Dear Dr. Cenlin He,

Reviewer #1, Dr. Robert Reinecke

In their manuscript, He et al. present a steady-state groundwater model forced by outputs of the global hydrological model H08.

Fig. 3a Please use appropriate colors - also in other figures.

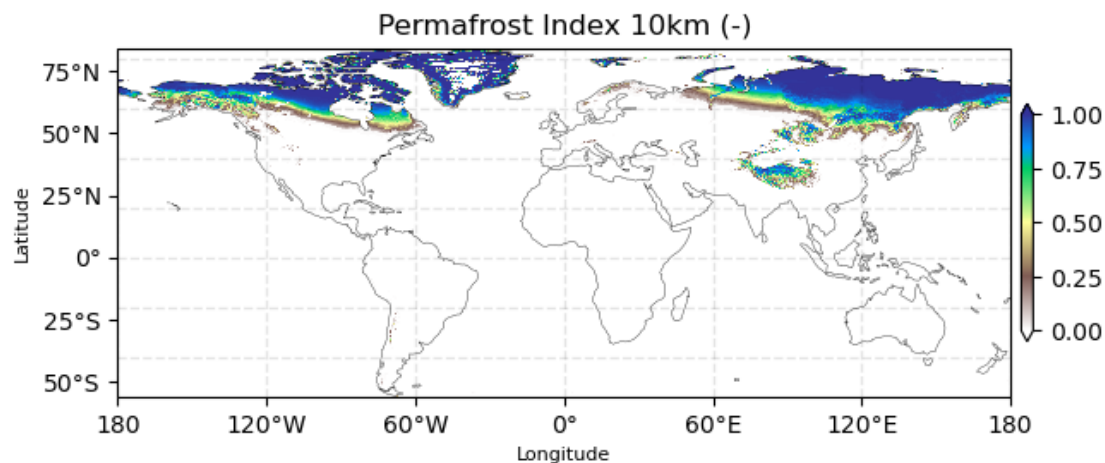
<https://hess.copernicus.org/articles/25/4549/2021/hess-25-4549-2021.html> is a good read concerning this. Also, the figure text does not include the units shown.

Response: We apologize for the inappropriate choice the colormap. We have now applied the colormaps from Scientific colour maps 7.0 to facilitate a more CVD-friendly visualization of our results for this figure and throughout the manuscript.

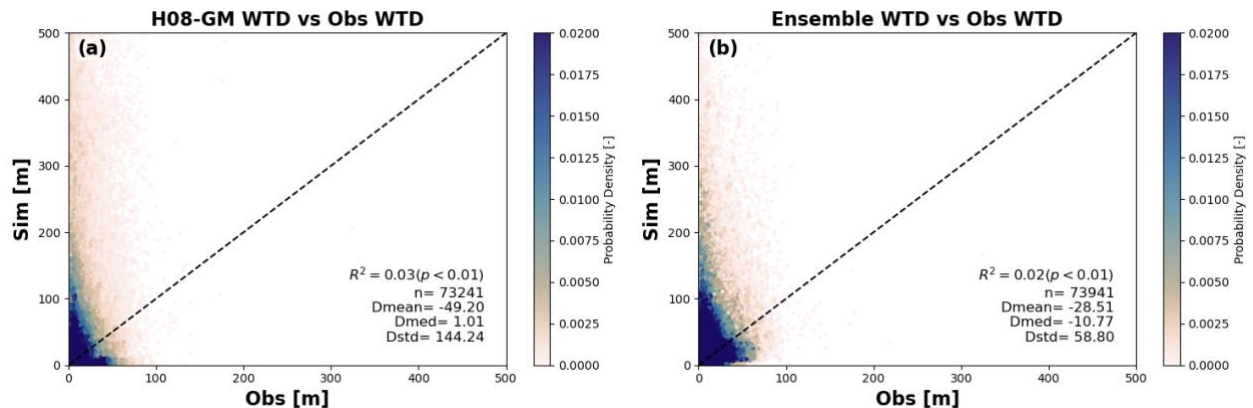
285: RRB is upper case in the text and r_rb in the table. Please be consistent. Also, what does "ref" mean? What is the baseline value for this?

Response: Thanks for the careful reading. ref for K indicates the mean hydrological conductivity from Gleeson et al. (2011); ref for Rch indicates the 40-year mean H08 recharge; ref for r_rb. indicates 1 day. We have made the wording consistent and added explanation in Table 1's caption.

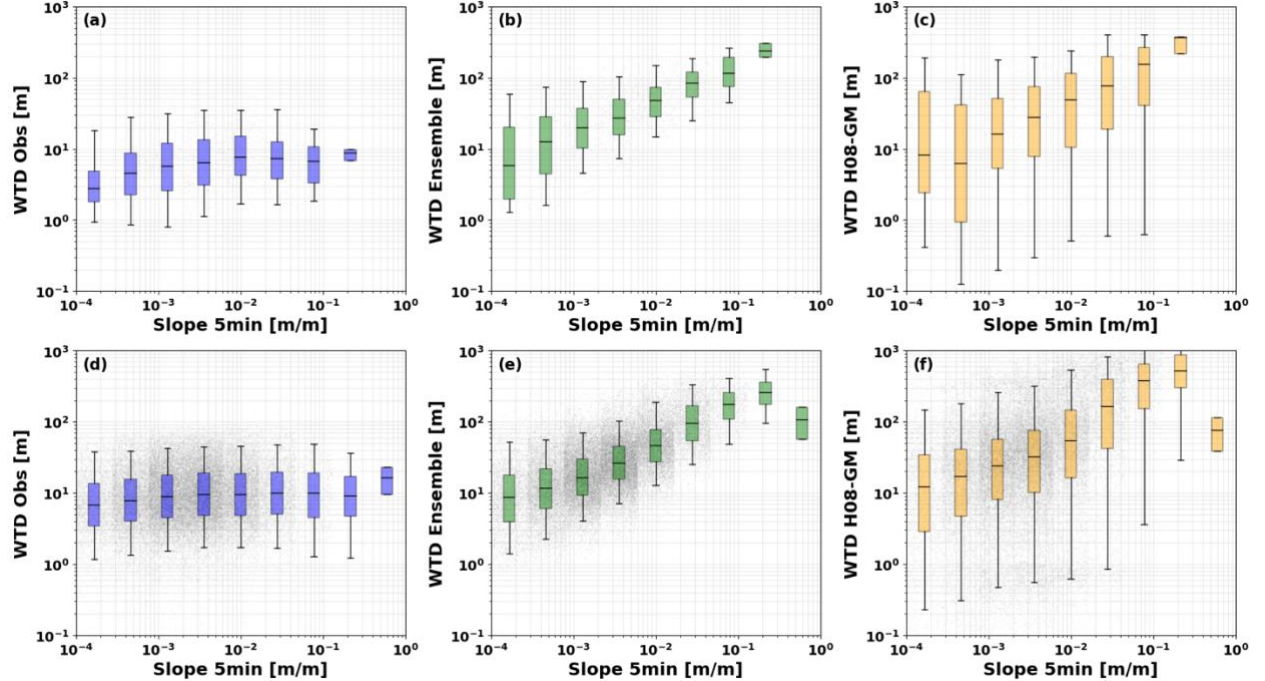
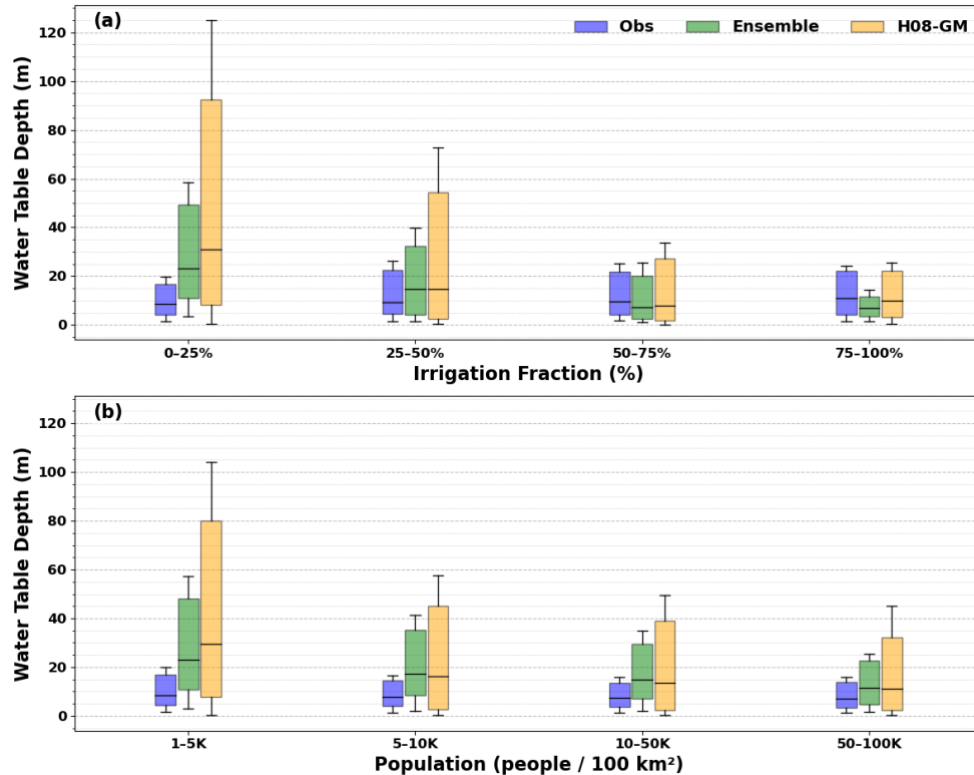
304: I would disagree with this. The head is what the model actually simulates, but what is relevant for many applications, e.g., in determining whether groundwater is available to humans or ecosystems, is WTD. Furthermore, calculating statistical metrics such as an error metric on the head is likely very biased by the topographic influence that is encoded in the head distribution. Scatterplots look very different depending on whether head or WTD is shown. Please show 1) scatterplots of simulated head vs. observed and scatterplots of simulated vs. observed WTD. See

also Reinecke (2020) for a related discussion. Furthermore, I suggest comparing your outputs to other existing steady-state simulations. You could even use the ensemble published with Reinecke et al. (2024).

We thank the reviewer for highlighting this important point. We agree that water-table depth (WTD) is the more application-relevant metric (e.g., for human/ecosystem groundwater accessibility). We have therefore prepared the scatterplots of WTD between H08-GM and Observation, and compared it with the results with the ensemble-mean WTD from Reinecke et al. (2024) as well (Section 3.2 in the revised manuscript).

As expected, the model-simulated WTD, no matter from H08-GM or ensemble mean, compares poorly to the in-situ observations, suggesting this might be a common problem in all global groundwater models. Two reasons could be plausible: (1) WTD embeds biases from both DEM and groundwater head so that the bias of itself might be exacerbated; (2) The spatiotemporal inconsistency of WTD in Fan et al. (2013) and the model simulations, i.e., most observations of Fan et al. (2013) only have one reading, and since they are in-situ observations, they cannot represent the 10km x 10km footprint. See a more detailed discussion in the revised manuscript (Line 390 – Line 398).

As the reviewer suggested in a later comment, we have also compared the WTD-slope functional relationships under different climate regimes in the figure below (top row for the energy-limited regime and bottom for the water-limited). H08-GM resembles the ensemble-mean in both water-limited and energy-limited regions, but neither of the models' results follow closely to the observations.

However, we believe the model can perform reasonably well in some regions, if not in the global sense. Inspired by Reinecke et al. (2024), we evaluated the performance of H08-GM and ensemble-mean in terms of different irrigation area fractions and population densities. The results suggest that in high irrigation fraction areas (e.g., >50%) and high population density areas (>10K/100km²), both H08-GM and ensemble-mean show closer median and model spread of WTD compared to the observations (Figure next page). This is important since it is in these areas the groundwater matters more to human and agricultural water accessibility.

In conclusion, we agree that the poor model-obs WTD problem in H08-GM, so as in other global groundwater models, but the models can perform reasonably well in densely populated and irrigated regions. This should be an important research

direction in the future for the global groundwater modeling community. To highlight topic, we have included the above content in the newly added Section 3.2 in the revised manuscript.
